SAN ANTONIO WATER SYSTEM
Interdepartment Correspondence Sheet

Subject: Zoning Case Z2015211 (Tesla Motors San Antonio)

Date: July 8, 2015

ZONING FILE: TESLA MOTORS SA (FIGURE 1)
ZONING CASE: Z2015211
MAP GRID: 148, D5

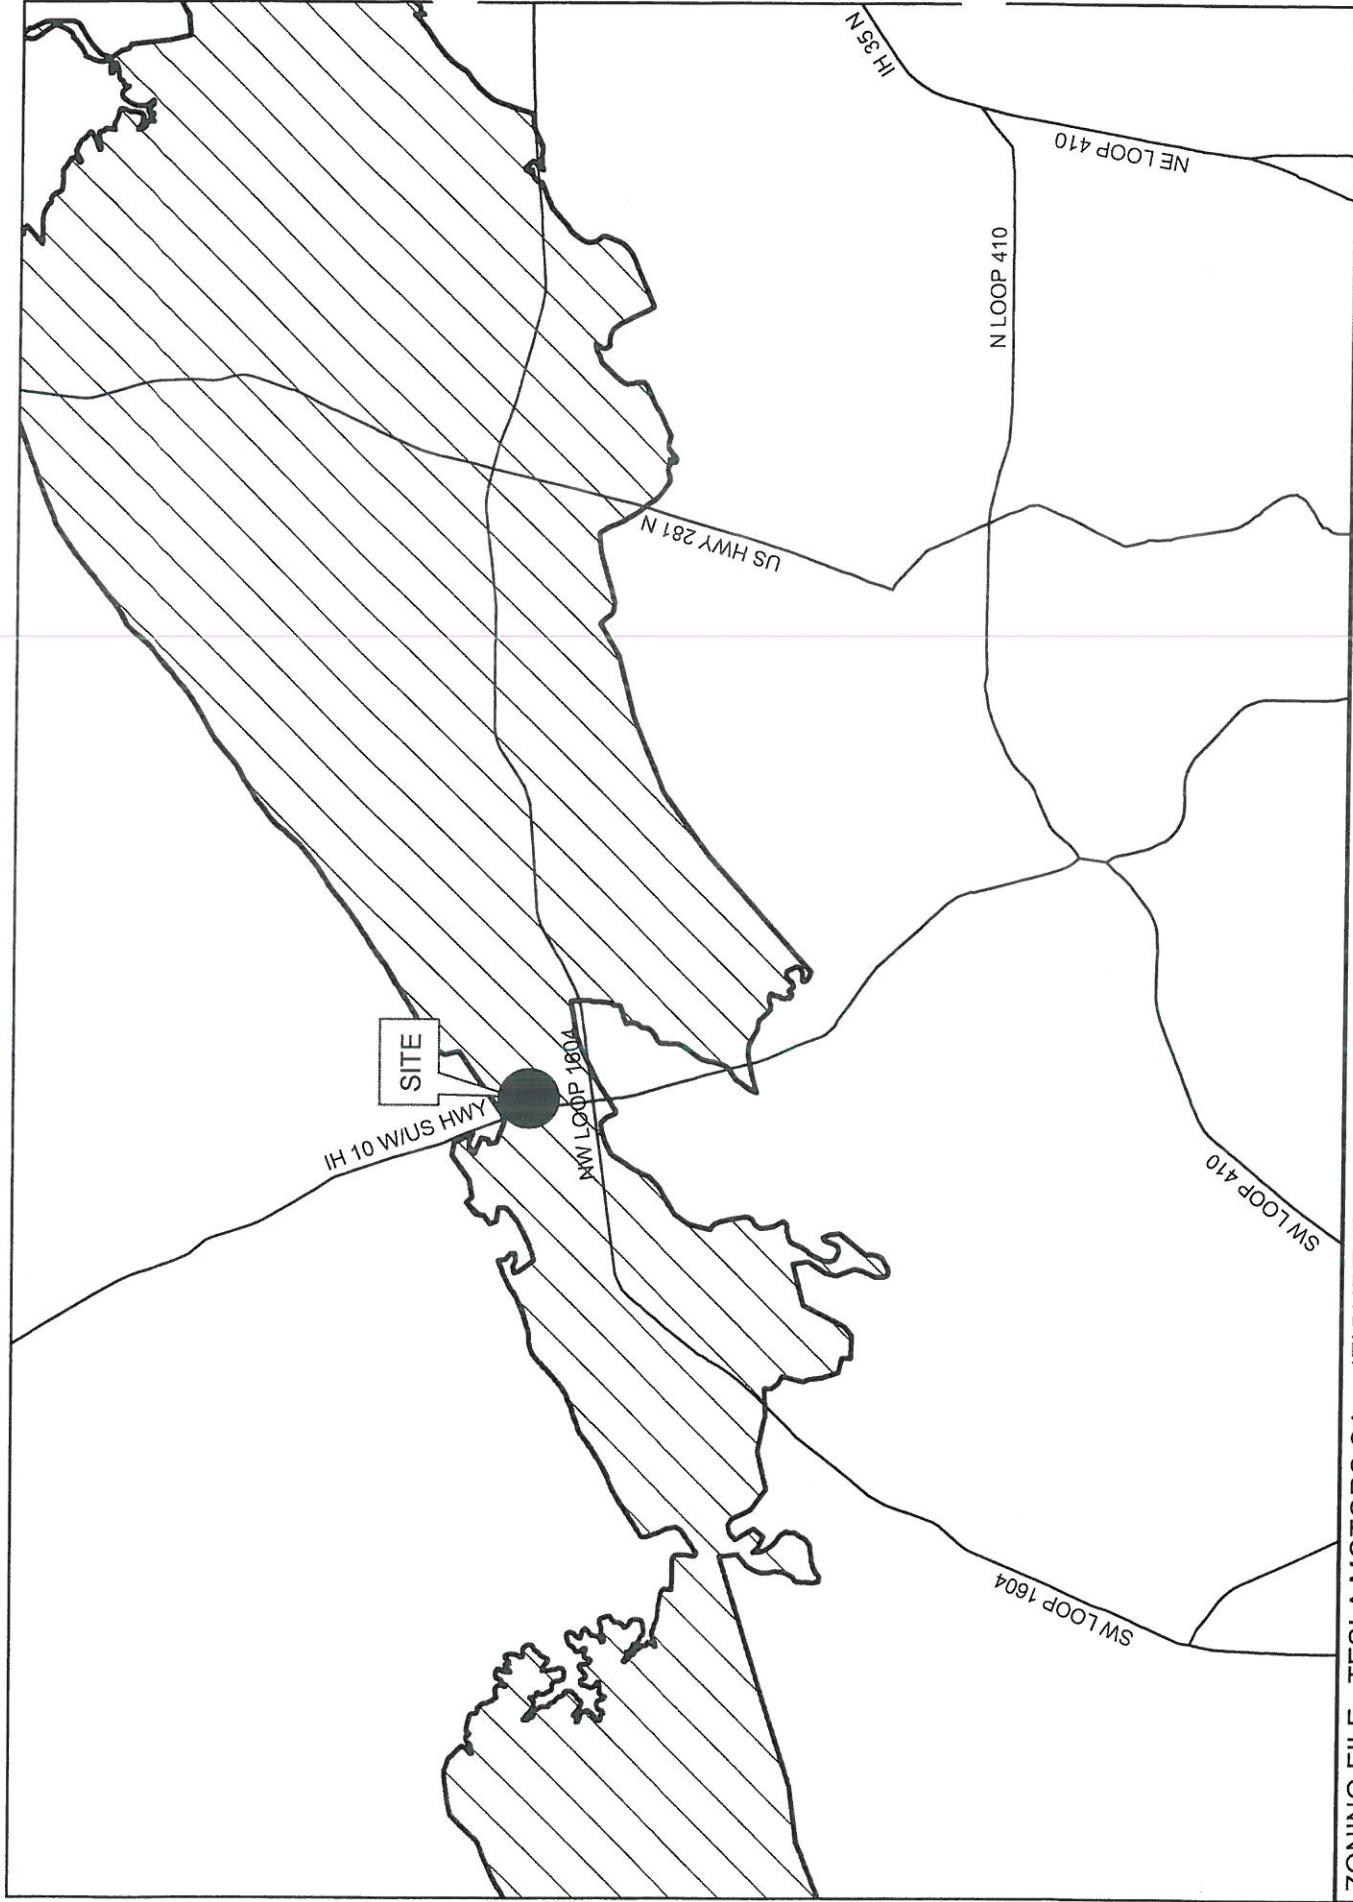
The subject property is located in City Council District 8, at 17100 Interstate Highway 10 West, at the northwest intersection of North Loop 1604 West and Interstate Highway 10 West. The property lies within the Edwards Aquifer Recharge Zone (Figures 1 and 2).
